# A47 Wansford to Sutton Dualling

### **Appendix 13.2 – Drainage strategy report**

A47 Wansford to Sutton  
Development Consent Order 202[x]

<b>Regulation Number:</b>	Regulation 5(2)(a)
<b>Planning Inspectorate Scheme Reference</b>	TR010039
<b>Application Document Reference</b>	TR010039/APP/6.3
<b>BIM Document Reference</b>	HE551494-GTY-HDG-000-RP-CD-00001-C01
<b>Author:</b>	A47 Wansford to Sutton Project Team, National Highways

DRAWING TITLE
DRAINAGE LAYOUT PLAN
SHEET 1 OF 7

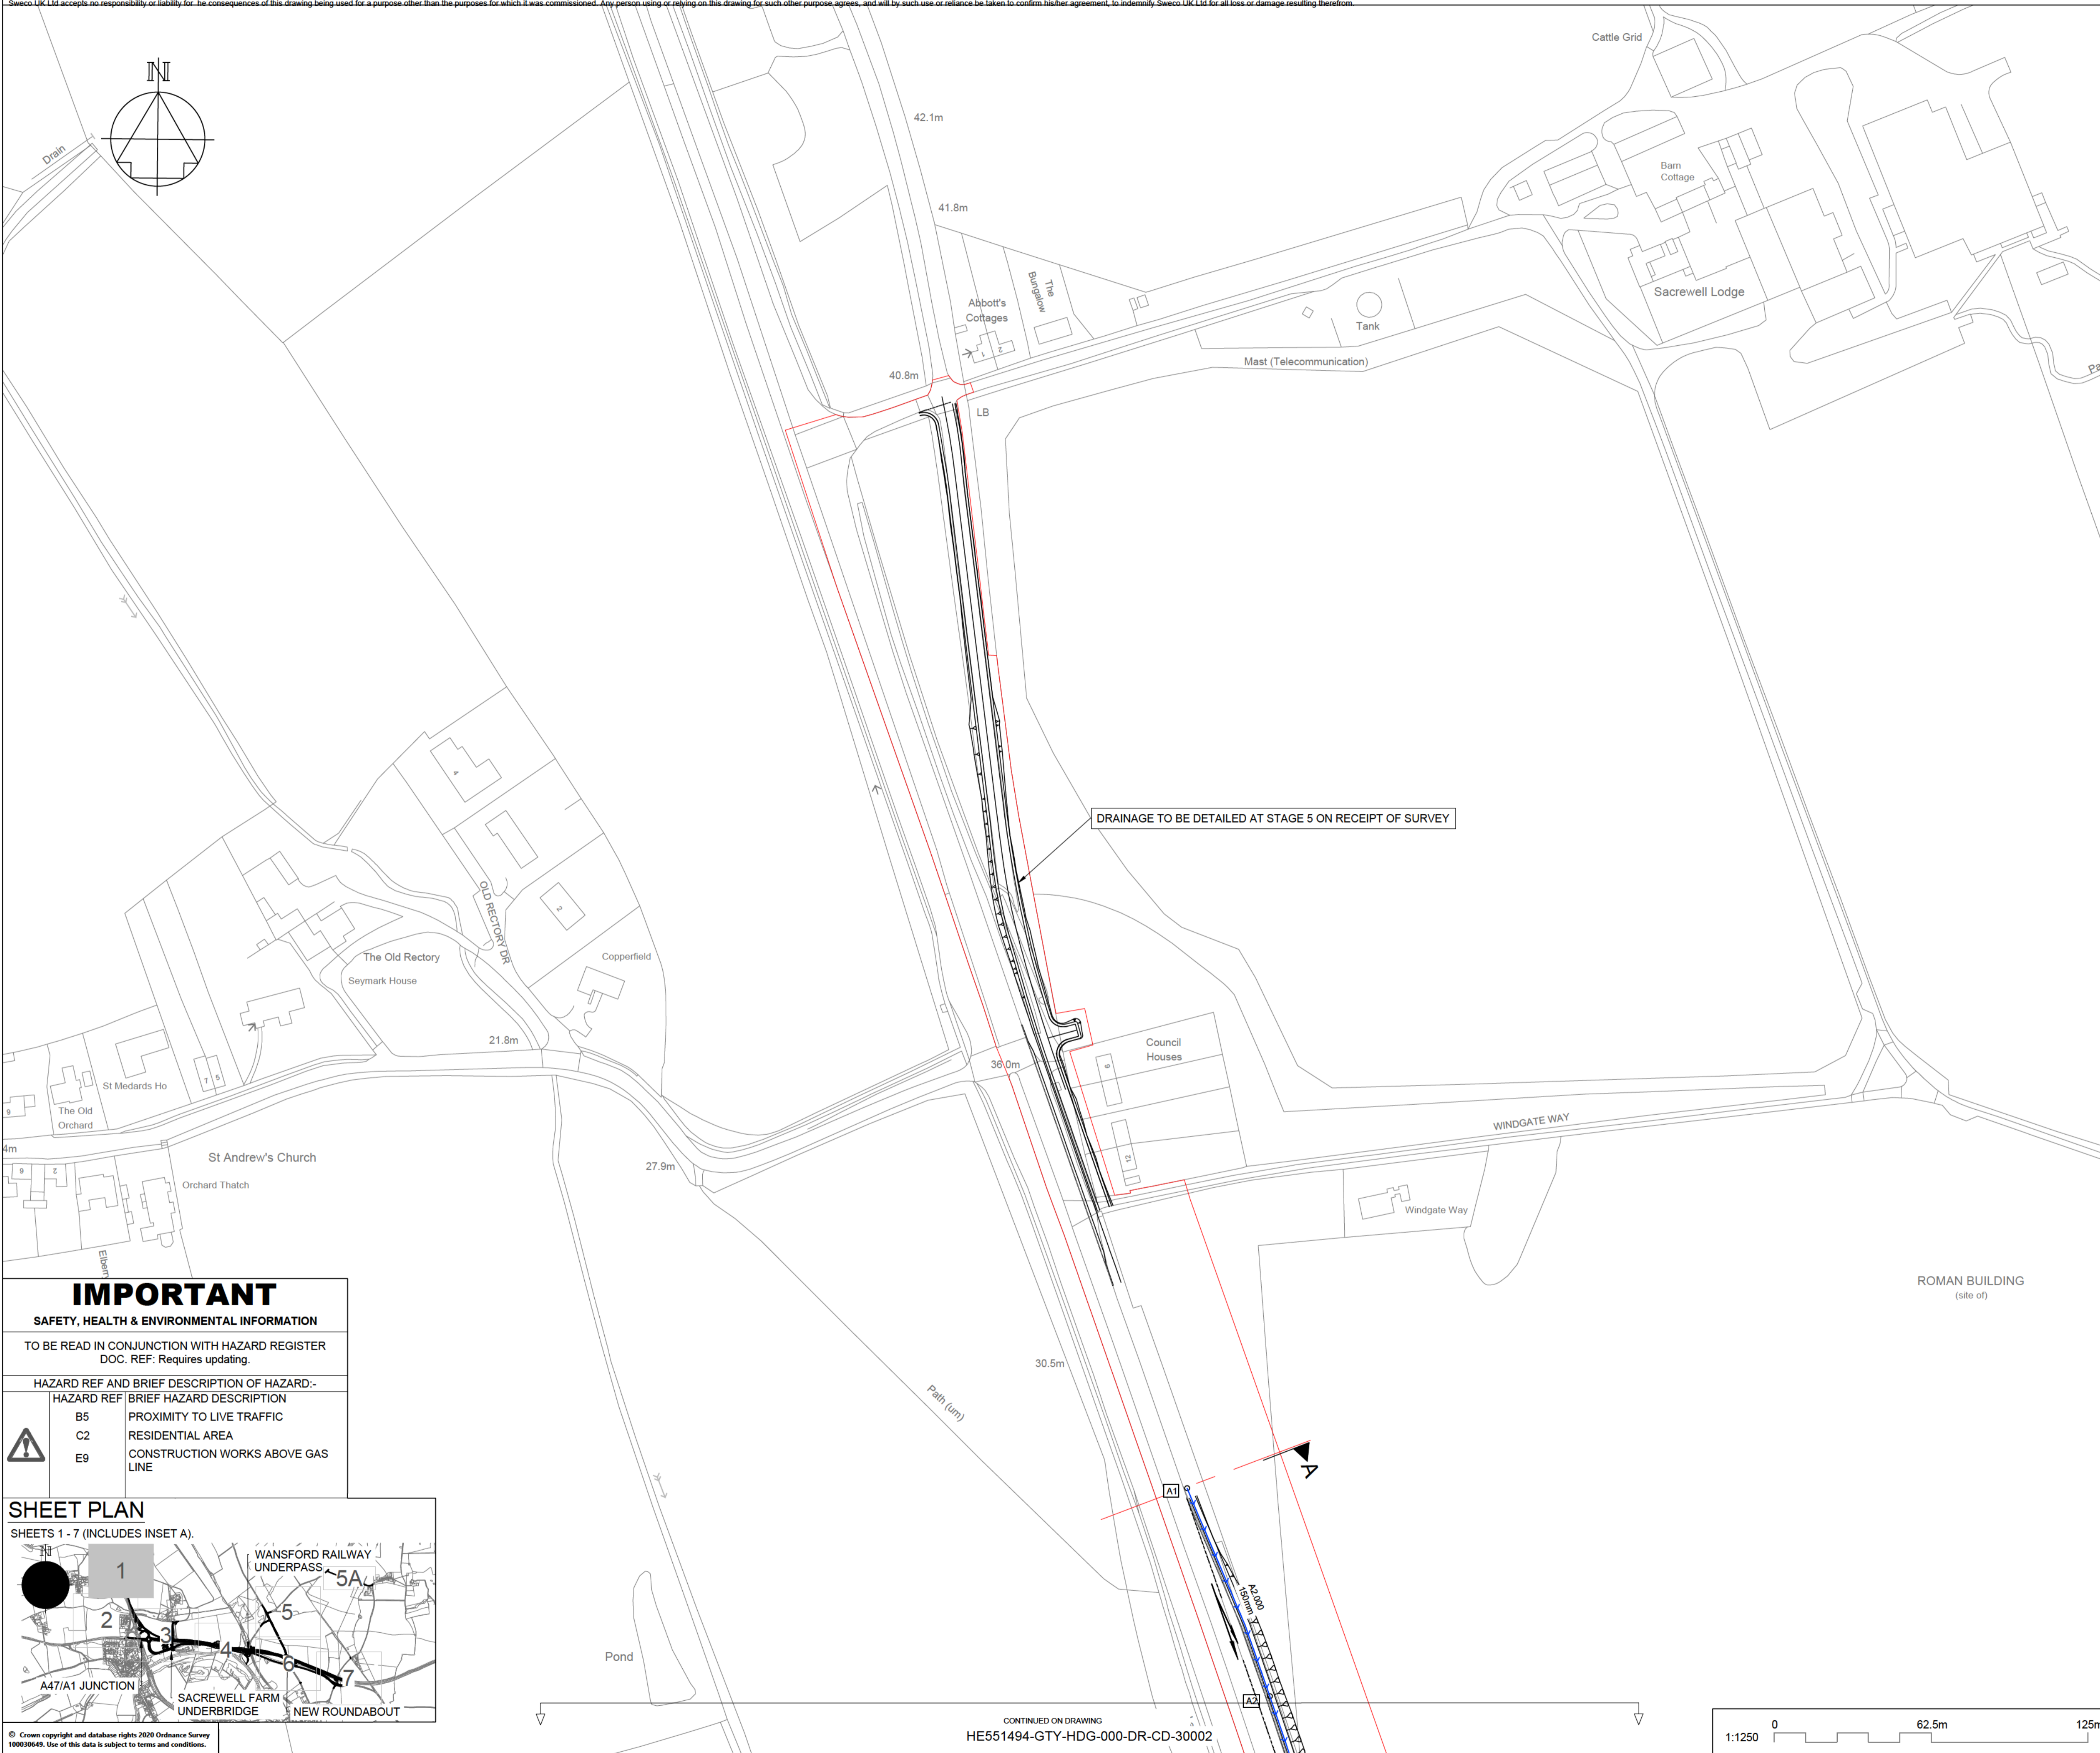
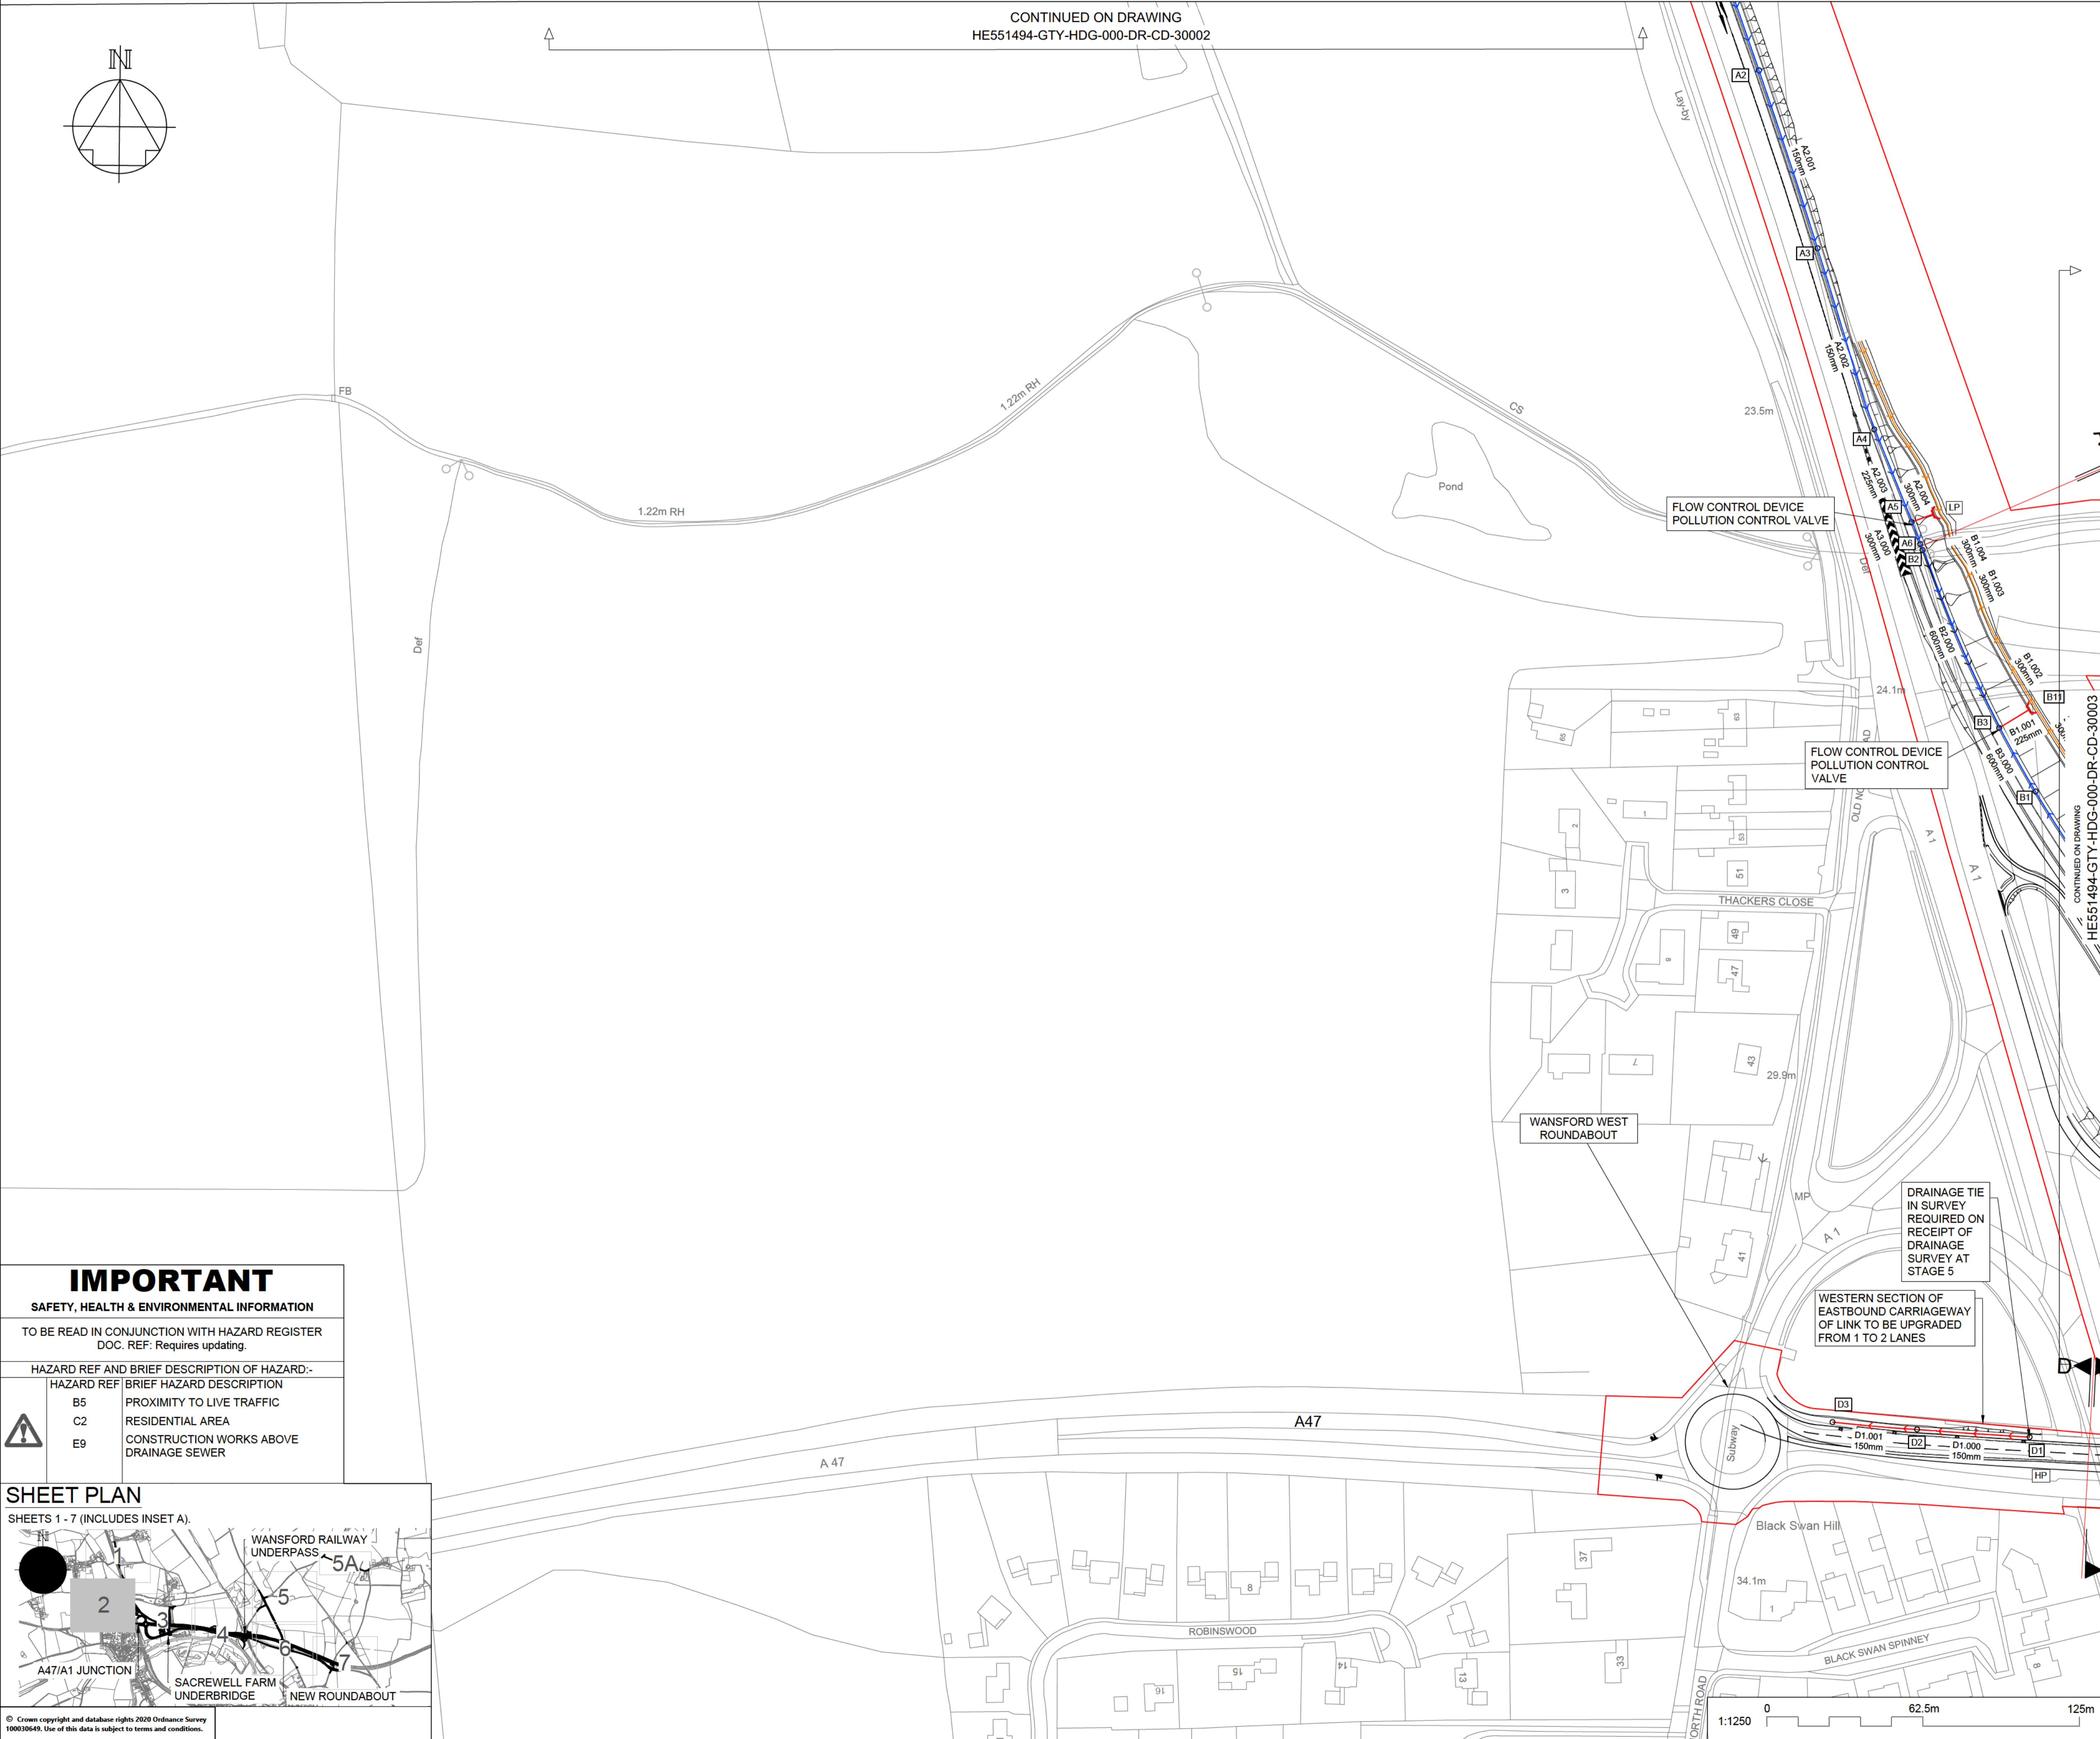
#### Sheet 1 and 2

1. Network A is shown to be restricted by a flow control device, as such we need confirmation of how and where flows will be attenuated for up to the 1 in 100yr rainfall event + CC allowance and how much storage is required and provided as part of this system.
2. Network D - as we understand it there is an existing system on this junction and no changes are proposed to this section of road, if this is correct then the network (D1-D7) need to be eliminated from the drawing.
